Discuss and consider a request by Jeff Carroll of Jeff Carroll Architects, Inc. on behalf of Eric Borkenhalen of Kohl's Department Stores for the approval of a Site Plan for an Animal Clinic for Small Animals without Outside Pens on a 0.636-acre portion of a larger

DEPARTMENT	REVIEWER	DATE OF REVIEW	STATUS OF PROJECT	
PLANNING	Bethany Ross	12/16/2022	Approved w/ Comments

12/16/2022: SP2022-064; Site Plan for The Pet Doctor

Water and Wastewater Items:

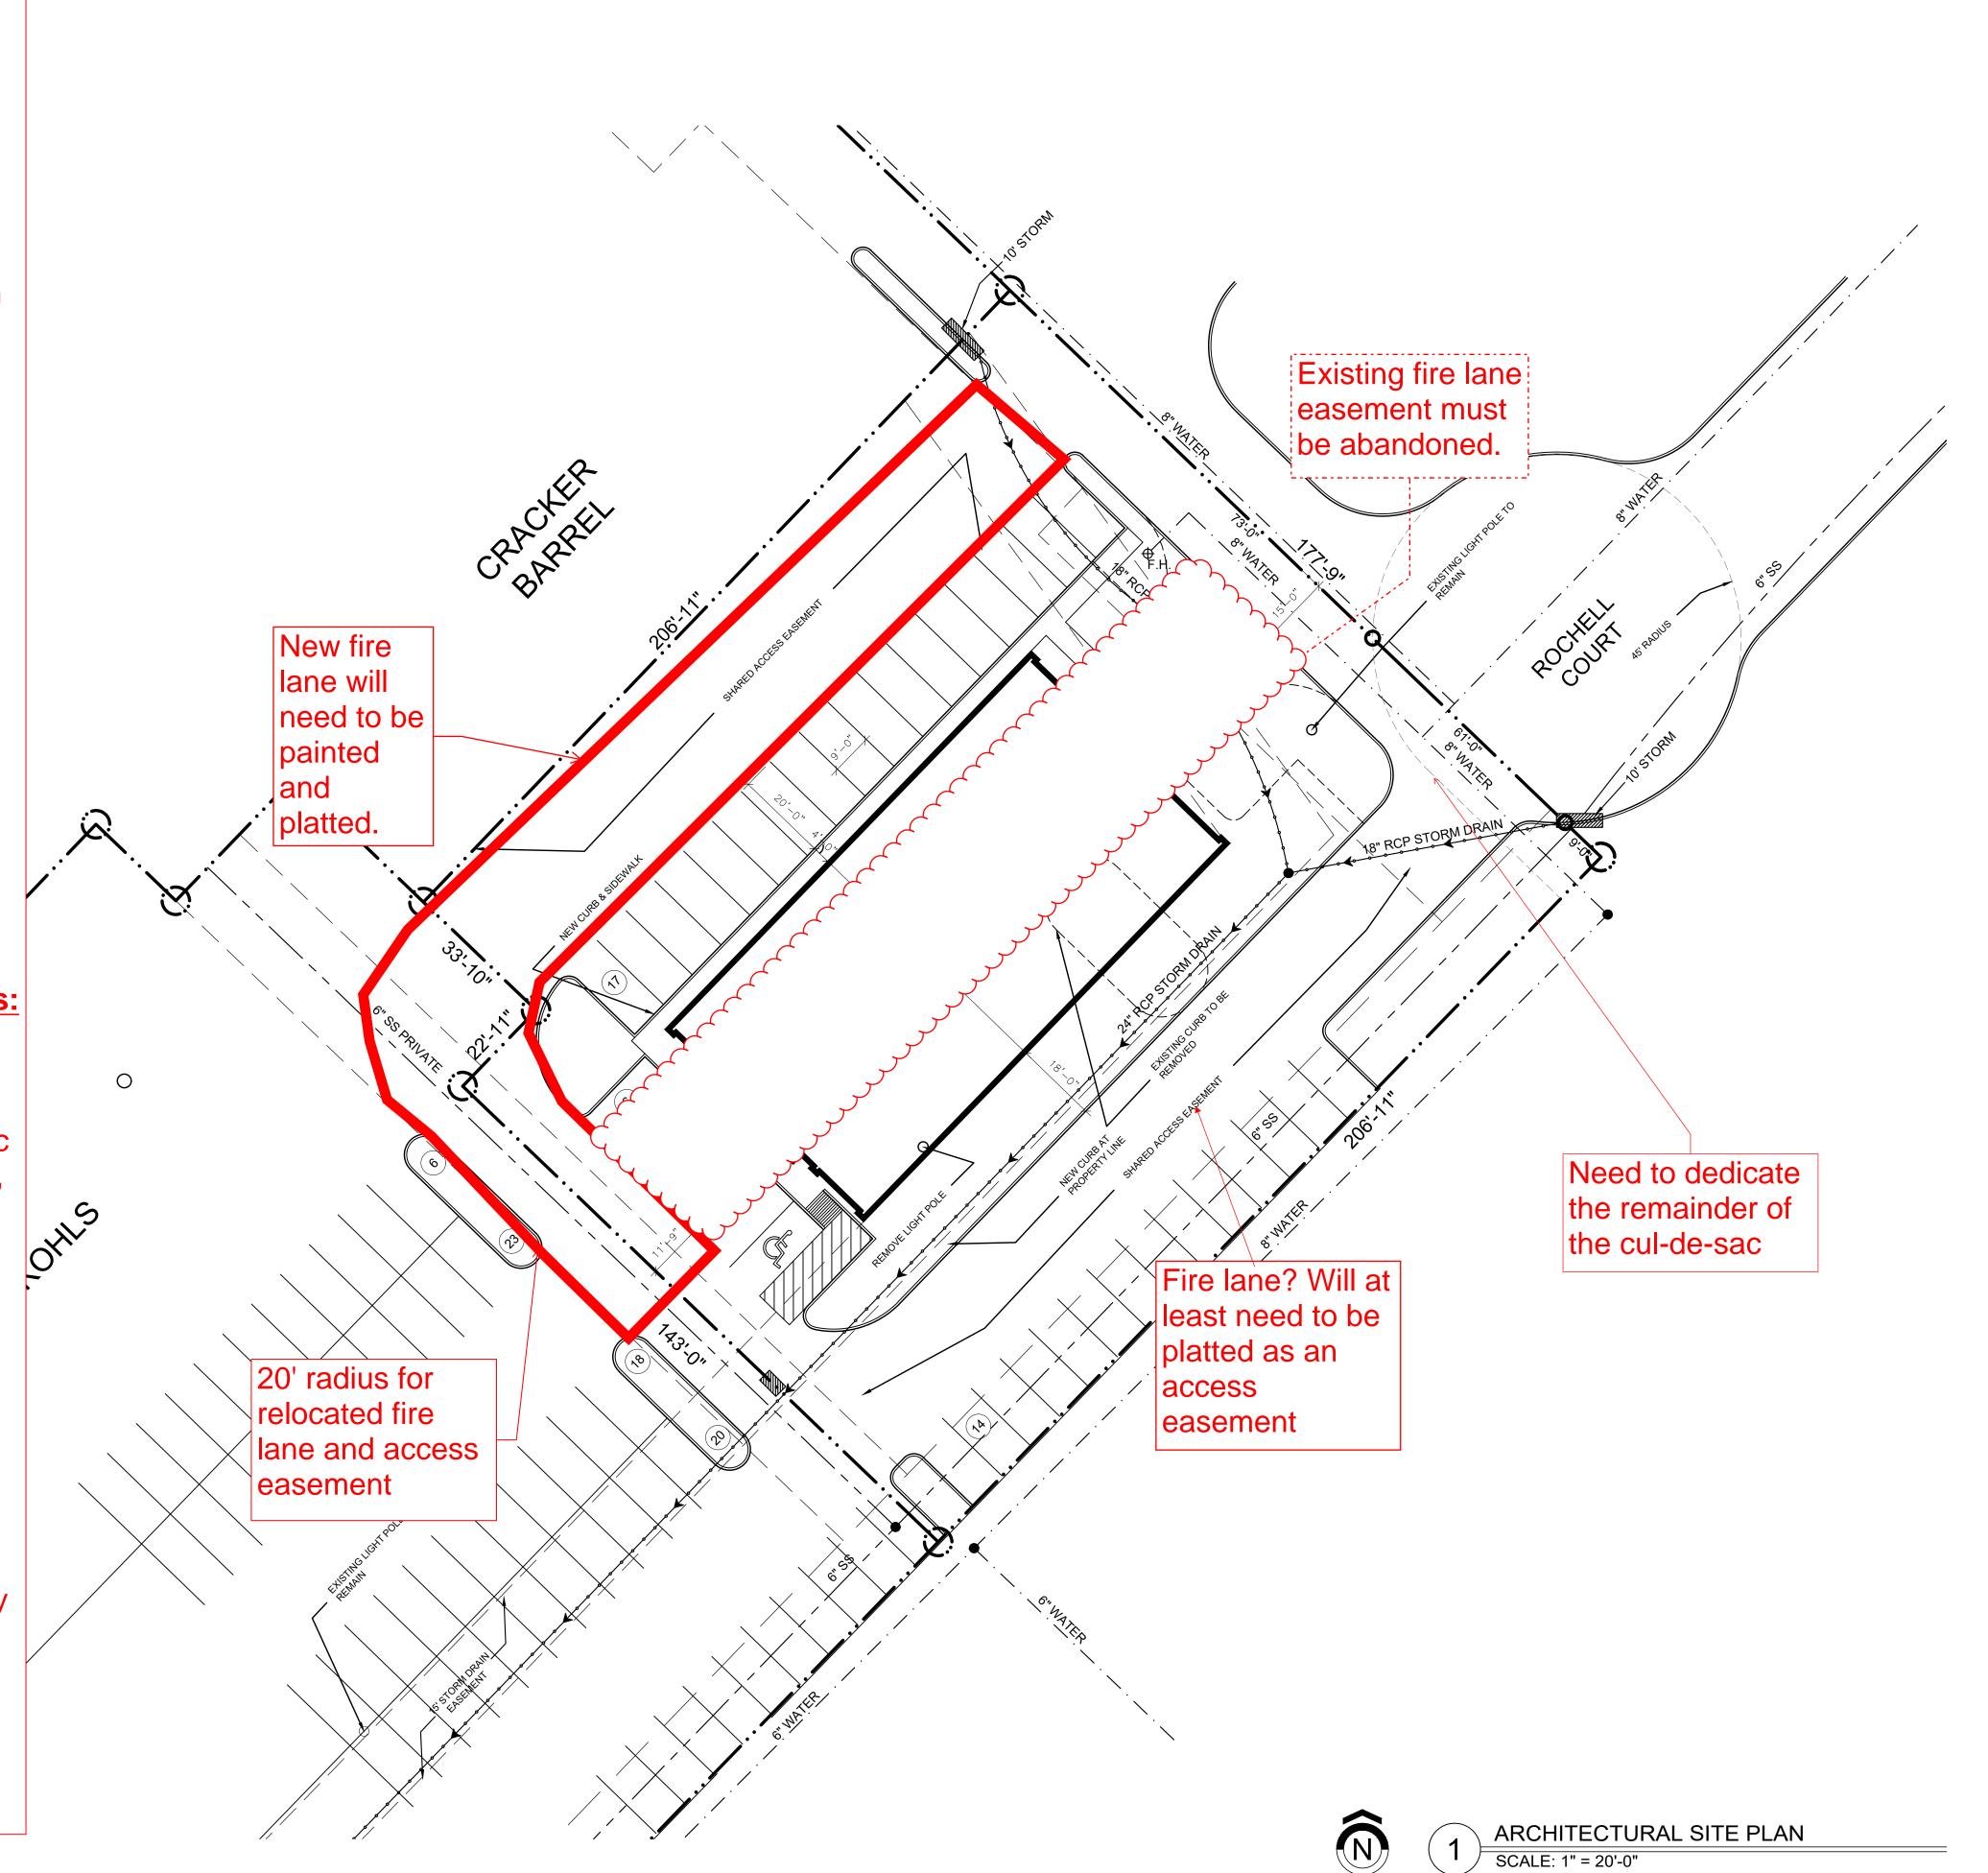
- 8" water will need to be looped in around the site.
- Only one "use" can be off a dead-end water line (Domestic service, irrigation, fire hydrant, or fire line).
- Water to be 10' separated from storm and sewer lines.

SITE PLAN

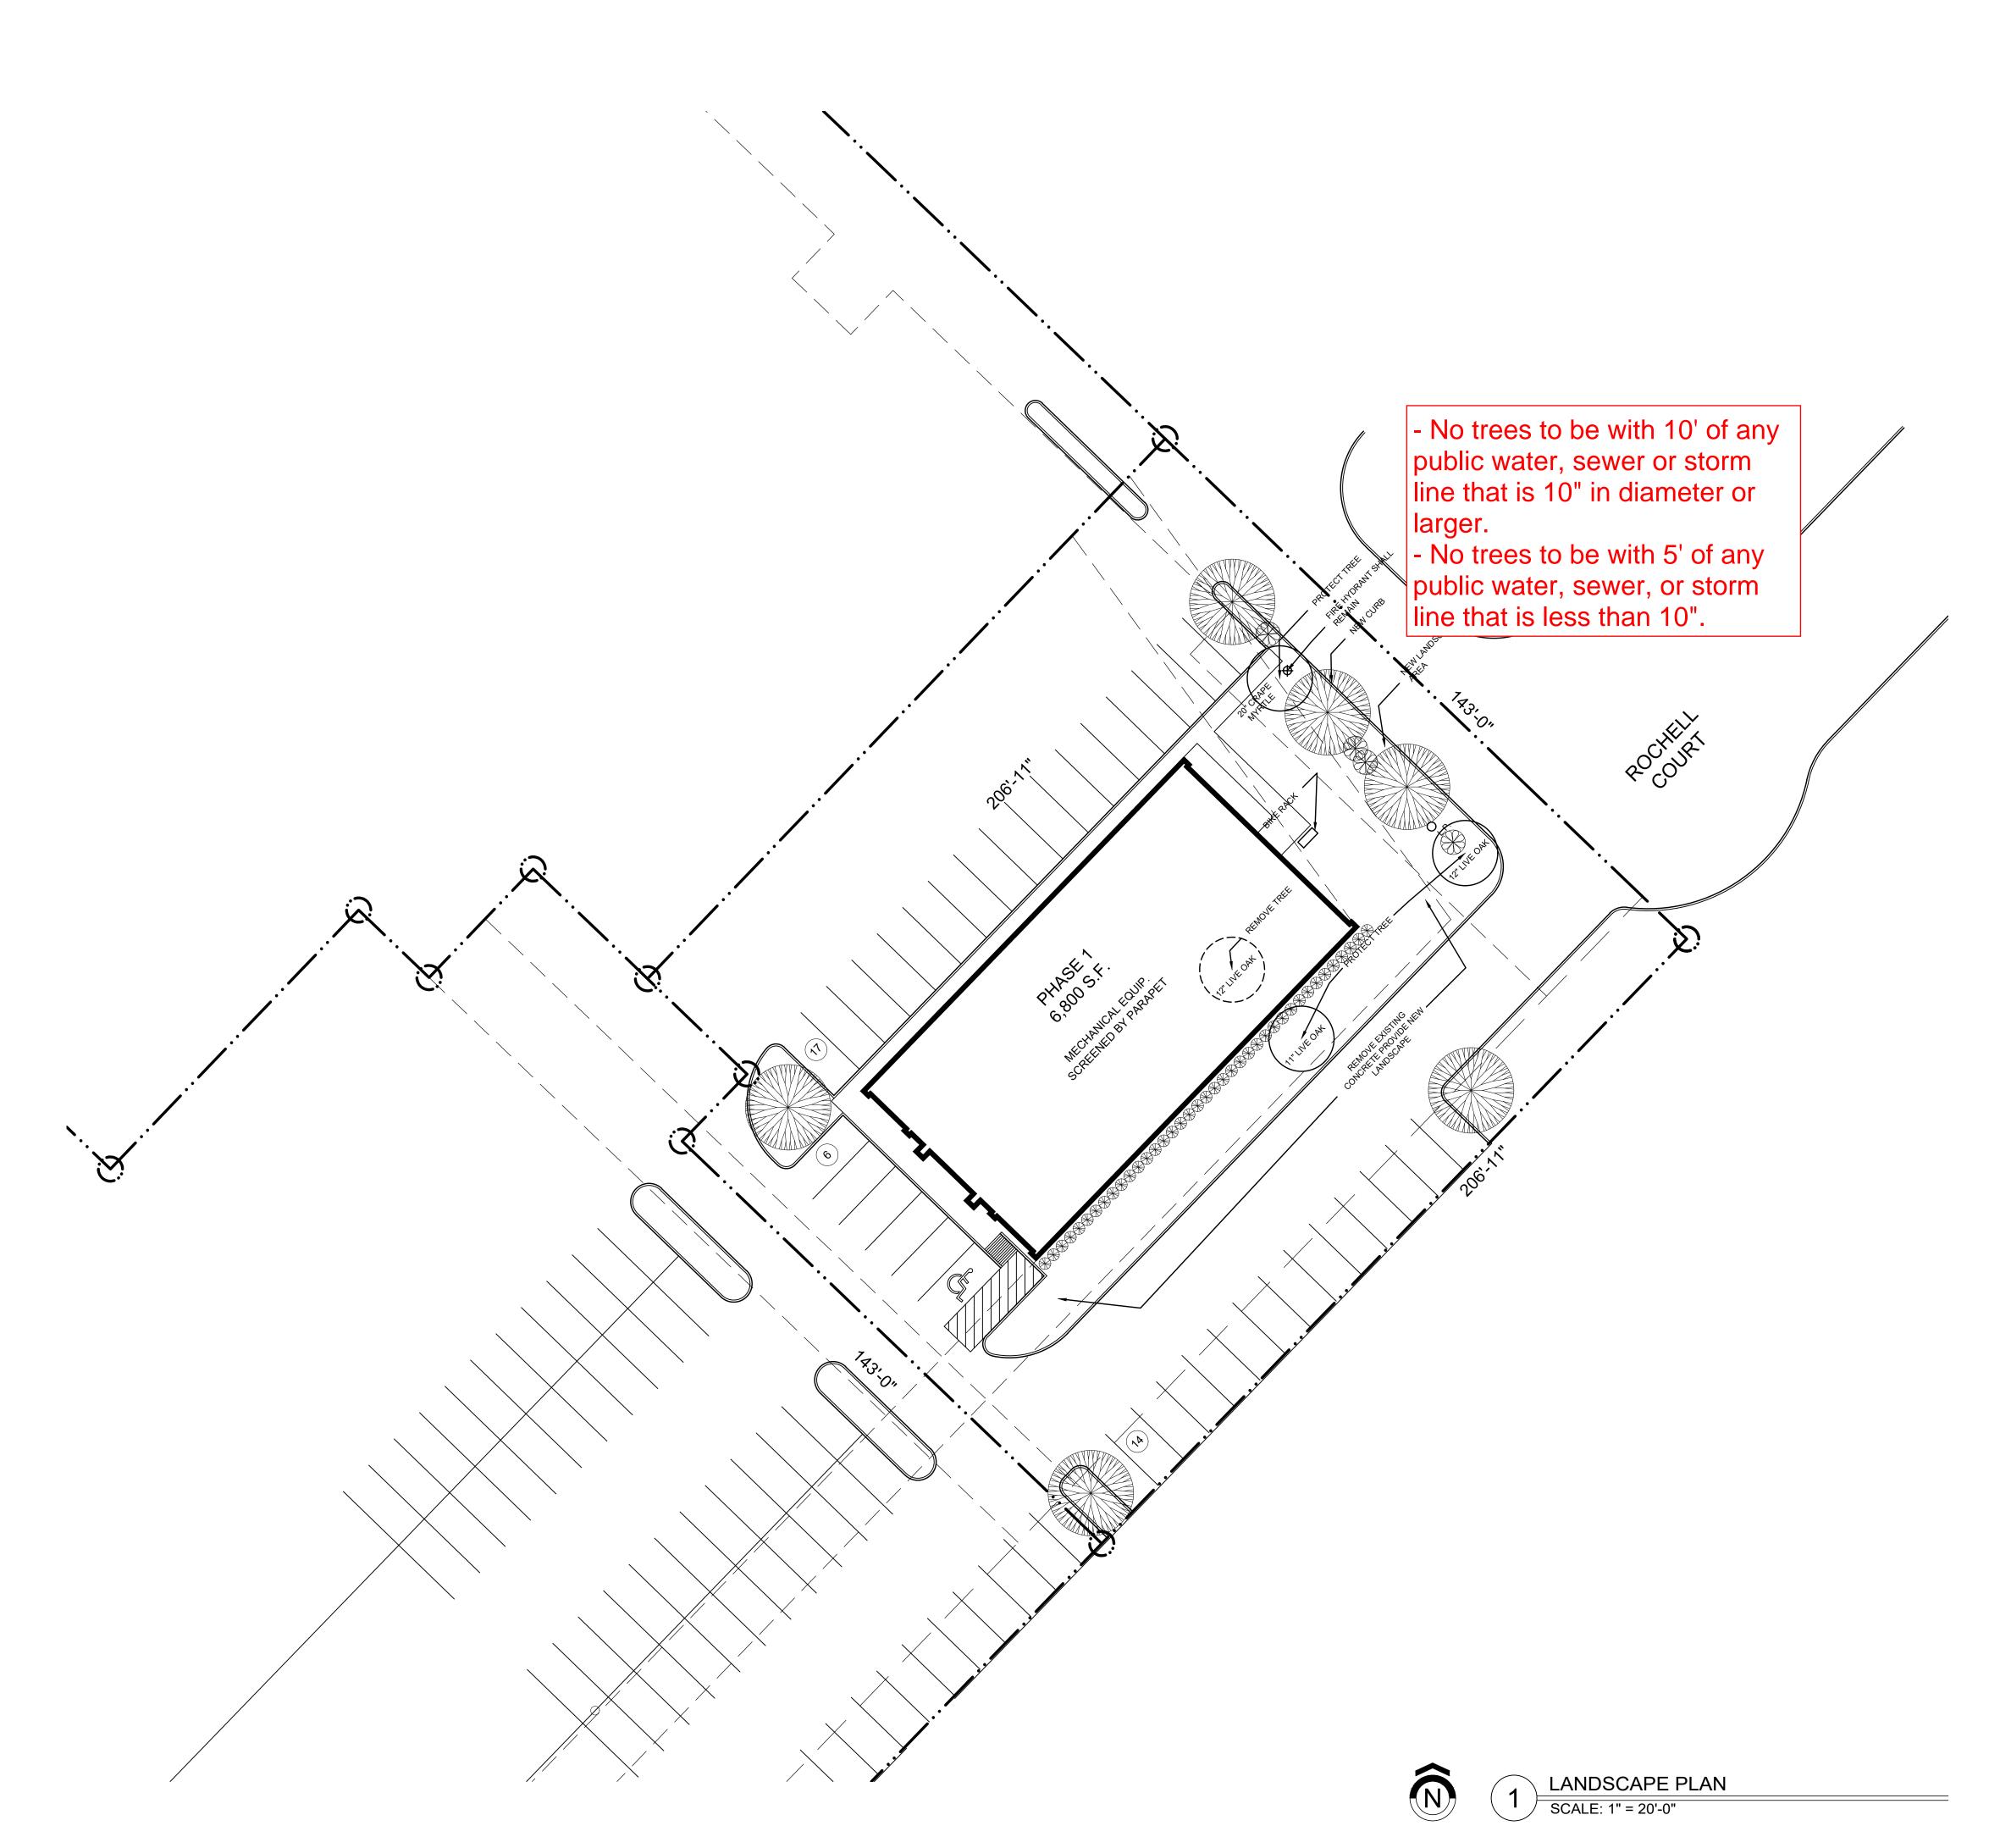
- 1.4 The subject property will be required to be replatted after the engineering process to establish the new easements.
- M.5 Site Plan
- (1) Please show the dedication of right-of-way for Rochelle Court. (Subsection 03.04.B, of Article 11)

- (2) Show the building setbacks from Rochelle Court dedication. (Subsection 03.04.B, of Article 11)
- (3) Please show the distance from the property line to the back of the building in the northwest corner of the subject property.

- (4) Please provide an exhibit showing all parking spaces are within 80-feet of a tree.
- (5) Since the building backs to a public row, please finish the back of the building in the same materials and using the same articulation as the front of the building.

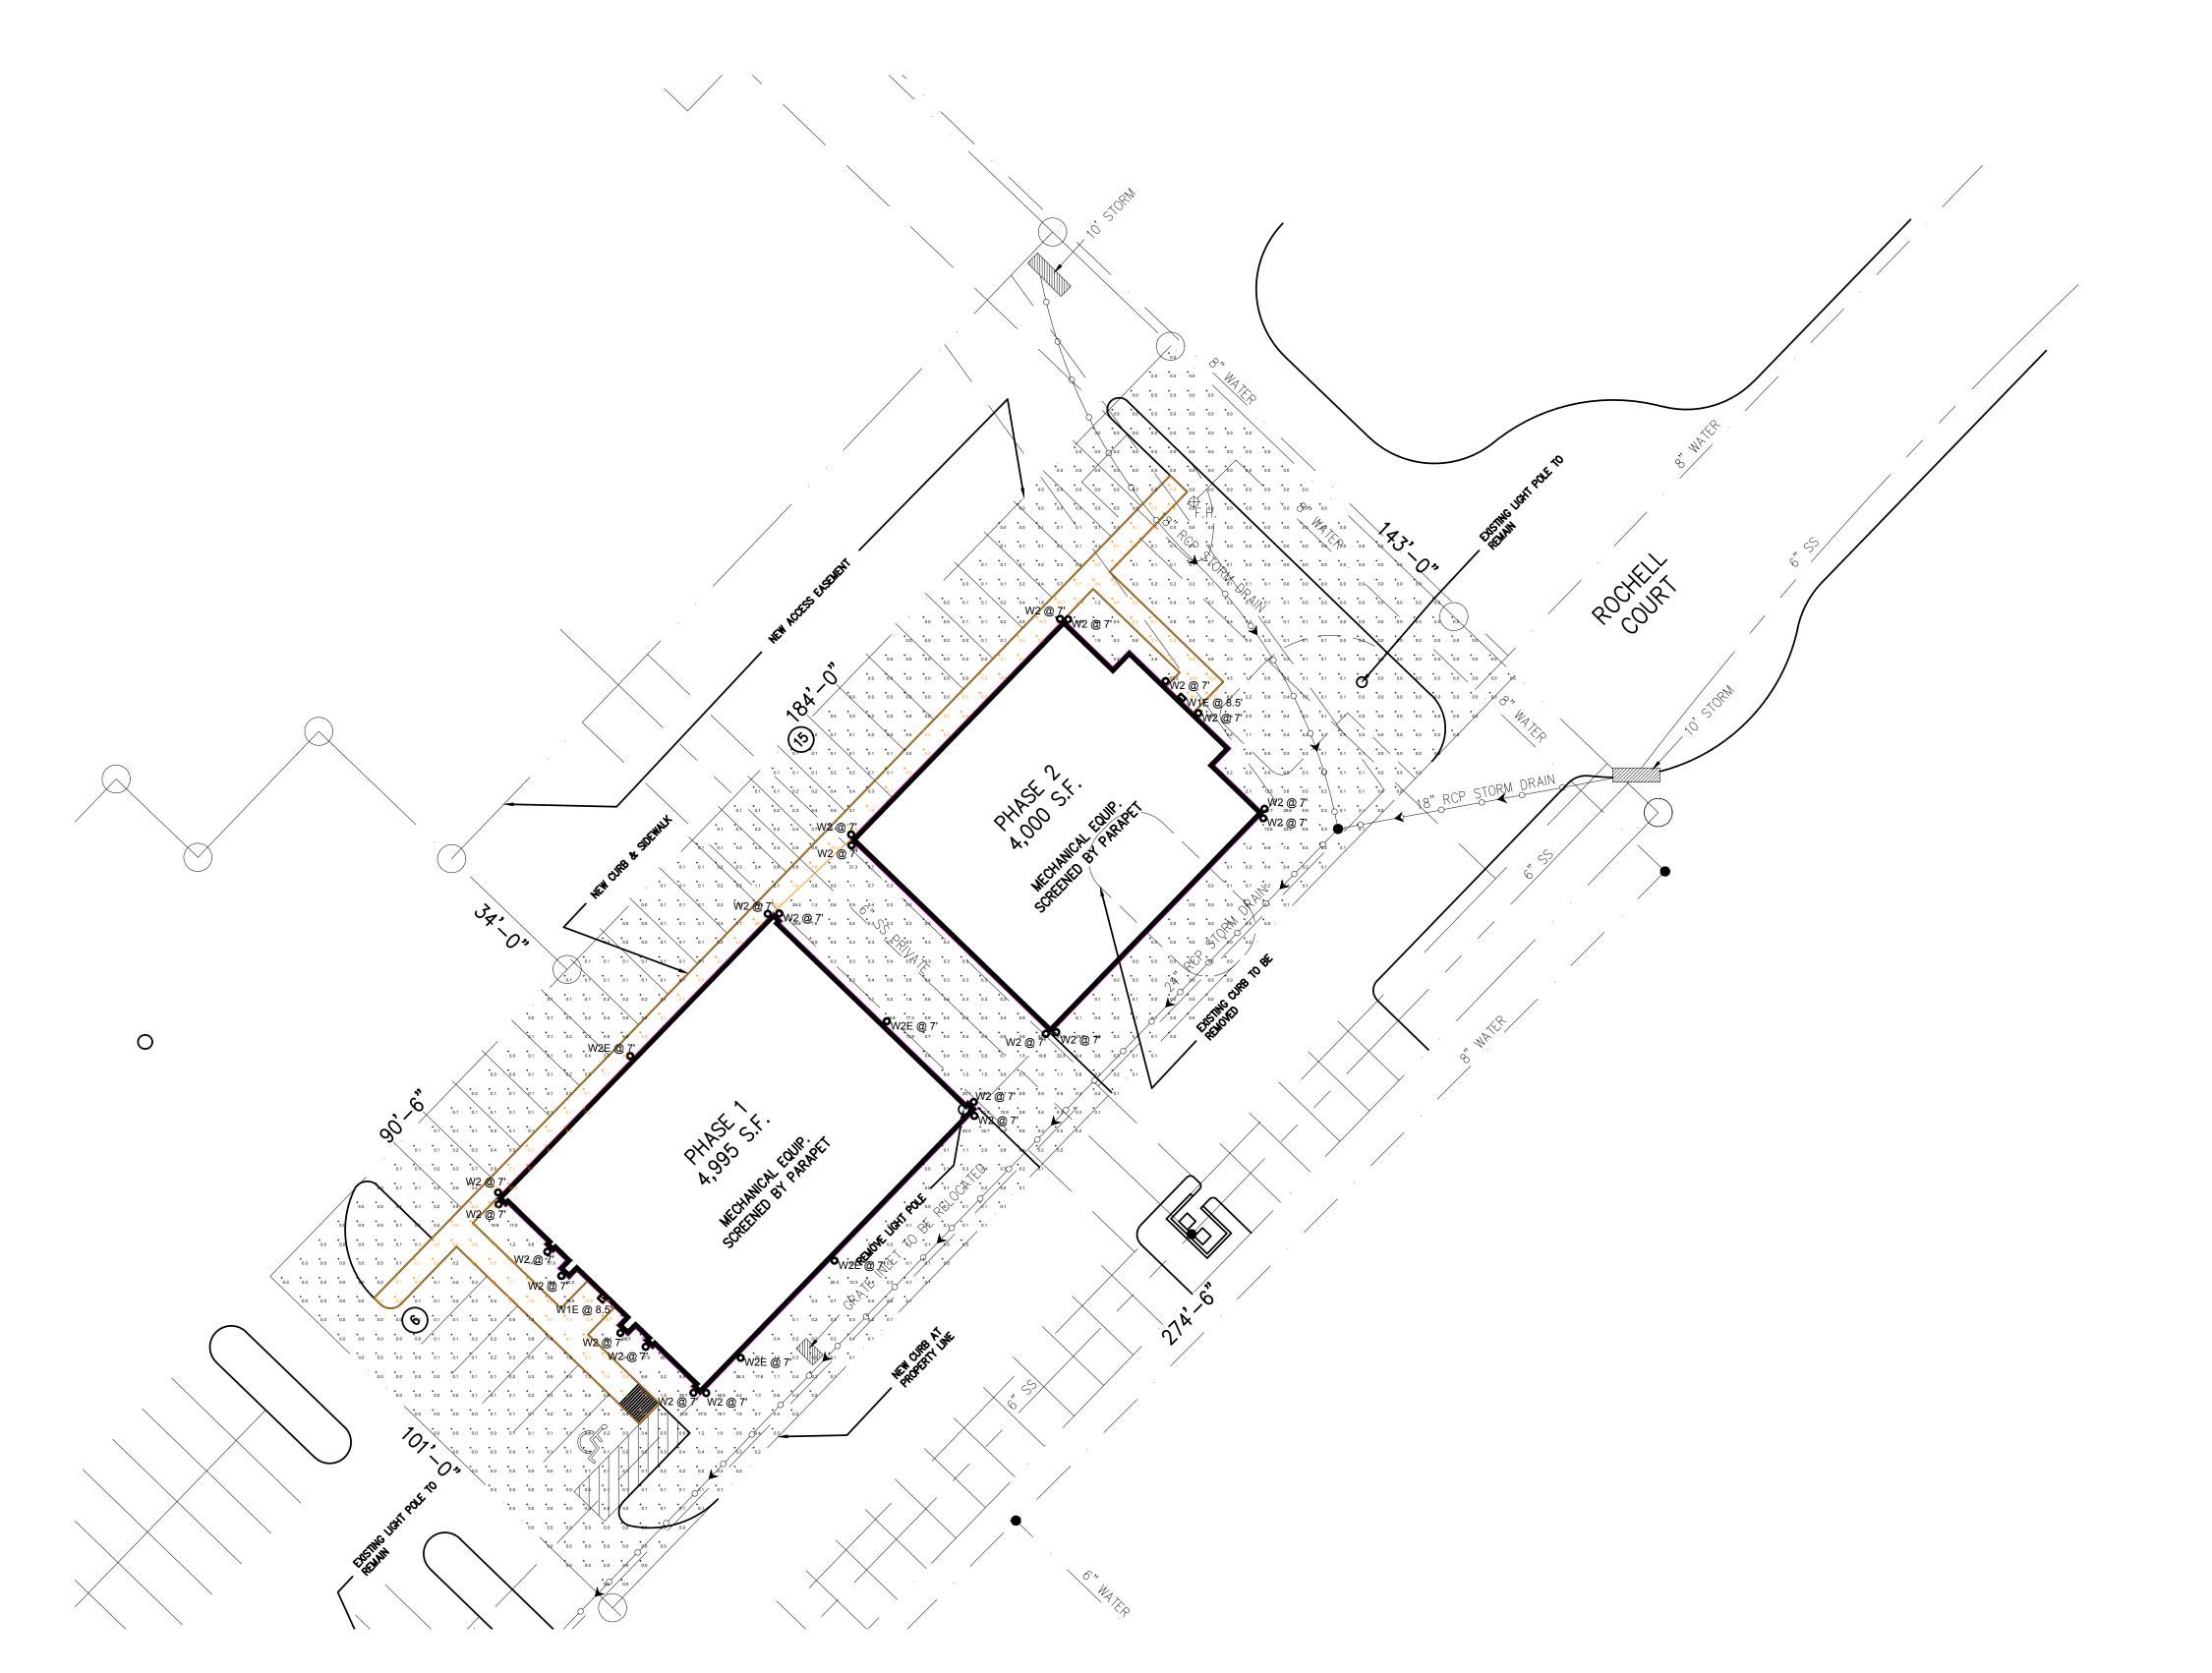
- (6) The photometric plan does not conform to the site plan or building elevations. Please make the required corrections.
- M.6 Based on the materials submitted staff has identified the following variances for this project:
